FISH PASSAGE CENTER

RE: NMFS Survival Study at The Dalles

Comments for BiOp 2000 regarding NMFS Survival Study at The Dalles

Figure 1. Plot of Survival by group 1997 to 1999 against spill volume at time of release.

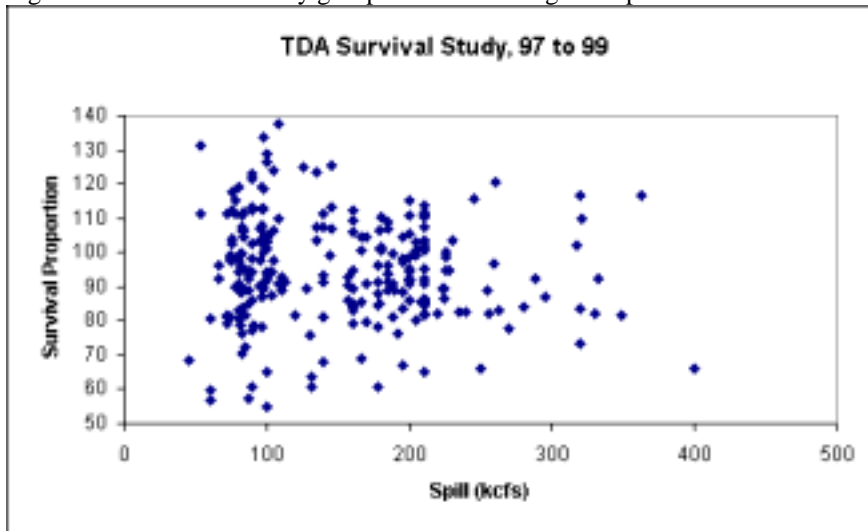
According to the study results, NMFS finds no significant difference in survival of fish released at 30% spill versus fish released at 64% spill. In fact NMFS shows a slightly lower, though statistically insignificant difference in survival for juvenile salmon released in the forebay of the dam versus reference release groups in the tailwater. From this study result NMFS has recommended decreasing spill at the dam. We have done a detailed analysis of the NMFS data and we have found some areas of concern in both the study design and the analysis.

Figure 2. Plot of survival of spring chinook and coho during spring 1999. Vertical bars separate release blocks (usually 3 release periods over two days grouped for a single spill volume). Time since prior release is the number of days since the last releases were done.

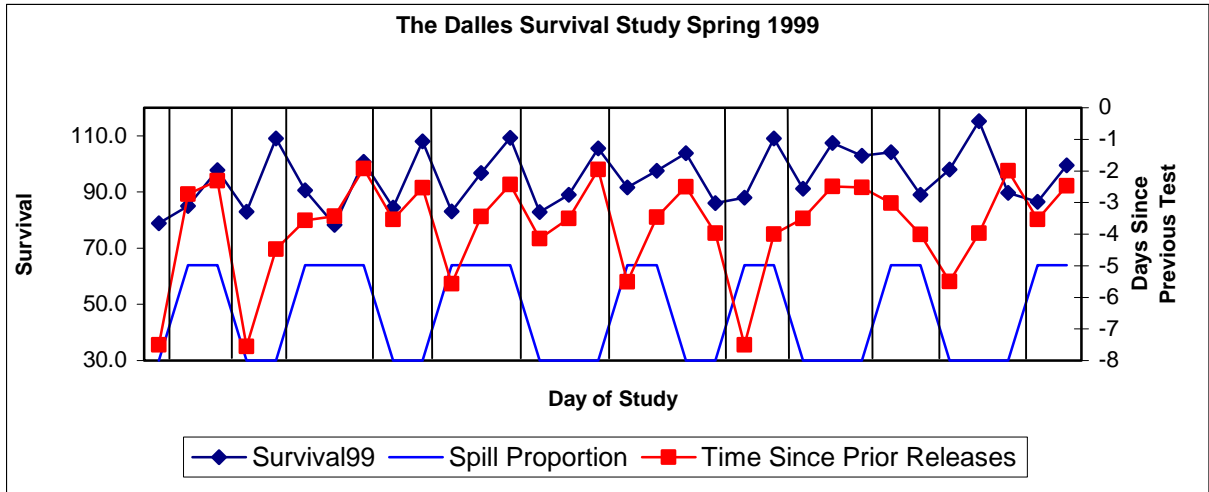
We plotted survival data over the season and compared these data to spill and time of day of release (Figure 2). NMFS blocked three releases over a two-day period (For example on day 1 there might have been a day-time release, then a night-time release followed by a night-time release a day later). In these blocks, it was apparent that survival for the first release group was lowest, followed by intermediate survival for second release and finally highest for third release.

This odd pattern could be an artifact of fish handling, such that those fish given longer recovery periods are better able to survive after release In any case, this is a troubling pattern that could seriously bias study results.

Figure 3. Plot of detections and Spill at Bonneville for a daytime release at The Dalles.

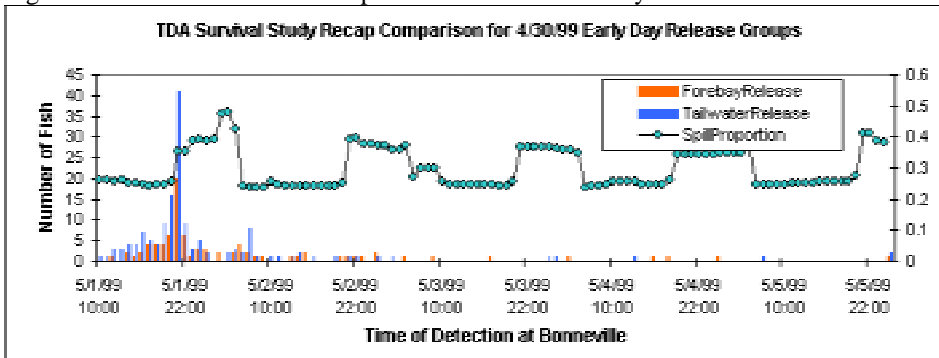
We calculated recapture proportions of all release groups. It was apparent that there was a consistently higher recapture proportion for daytime releases than nighttime release groups. This did not show up in differences in survival calculations because this pattern was true for both forebay (test) and tailwater (control) release groups. When we compared arrival time of these groups at Bonneville Dam, it appeared that a large proportion of fish from day-time release groups arrived at Bonneville Dam during the following day, when the project was spilling a lower volume, while night-time releases arrived at night during higher spill and that this probably accounted for the difference in detection probability (Figure 3 and Figure 4). Because of this difference between day and night releases we felt it necessary, when doing other analyses on recapture data to analyze these releases separately. Also, this difference pointed out the importance of operations at Bonneville, and time of arrival (based on time of detection) in determining recapture proportion. And consequently, the potential for operations at Bonneville to affect survival estimates of release groups where arrival times of test and control fish differed.

Figure 5. Plot of Arriving Percentiles of Release Groups; comparing forebay and tailwater group arrival timing.

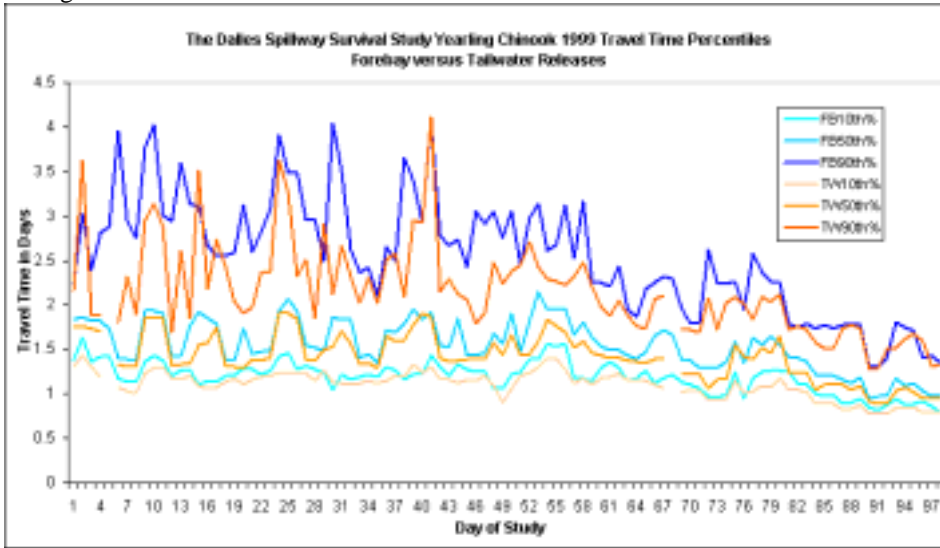
We compared arrival times of paired release groups, forebay and tailwater, based on time of release. On any given date, three groups of fish were released in the forebay, over a 30-minute period, followed by three tailwater releases two hours later. Generally, the 50th percentile of these tailwater and forebay release group pairs arrived at a similar time at Bonneville Dam despite the two-hour delay in release of tailwater groups, after tests groups had been released in the forebay. However, the 90th percentile of the test fish were almost always later in arriving than the control fish by anywhere from six hours to a day (Figure 5). It is difficult to say what result this would have on survival estimates. But two possible problems could result. First, their protracted arrival at the downstream dam could affect overall detection probability at Bonneville Dam, simply due to different spill proportions at that project when test and control groups arrive there. Second, it does demonstrate a significant delay in at least a portion of the forebay release groups, since on top of the two hour earlier start than tailwater release groups a portion of these fish are further delayed.

to Figure 7. Travel time comparison between test releases and run-at-large fish in the TDA BON reach.

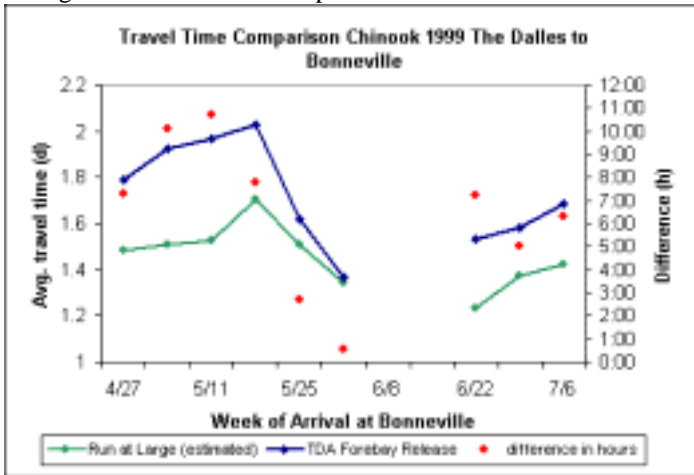
Finally, we were curious about the effect of handling the fish might have upon the study. Are these test fish representative of actively migrating fish. To test this we looked at one the travel time of these experimental fish versus run-at-large fish migrating downriver during the same time period. We compared travel time of run-at-large fish detected at both John Day and Bonneville dams to test fish released in the forebay of The Dalles Dam and recaptured at Bonneville Dam. Generally the forebay release groups were found to travel slower than would be expected for run-at-large fish traveling through the same reach (Table 1 and Figure 7). Indeed, during most weeks of the study, we calculated a 6h

to 10h longer mean travel time for test fish through this reach than we would expect for run-at-large fish traveling the same reach.

Given a travel time of 36 hours, this represents a 12 to 20% increase in mean travel time for test fish versus active migrants. This difference in travel time suggests the test fish may not behave in a way that is indicative of migrating fish. Indeed, coupled with their relative difference in travel time to control fish (we.e. two hour delayed release), it suggests there is some delay in their travel time through the reach that is unrelated to the conditions being tested (spill proportion, day or night release). This delay, could significantly bias the study. Especially if predation is the main source of mortality, as has been proposed by NMFS researchers. If test fish are delayed after release due to disorientation or stress, and are then exposed to high predation pressure during that
